Proposal ① Modify cartridge configuration as shown below

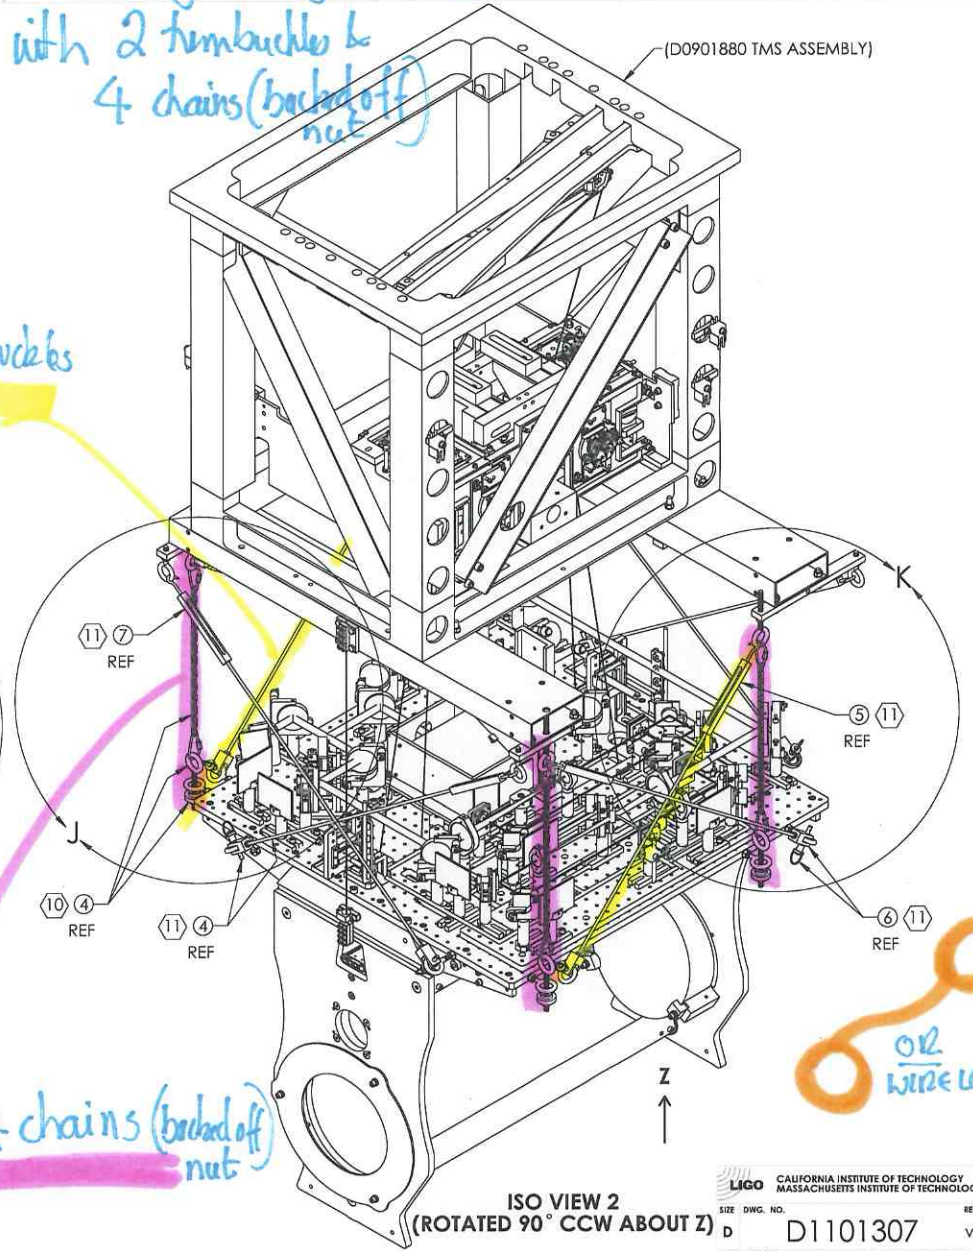
with 2 turnbuckles & 4 chains (backed off nut)

2 turnbuckles

4 chains (backed off nut)

OR WIRE LOOPS.

Proposal ② Modify cartridge with 2 wire loop replacing 2 turnbuckles & 4 chains (backed off nut)
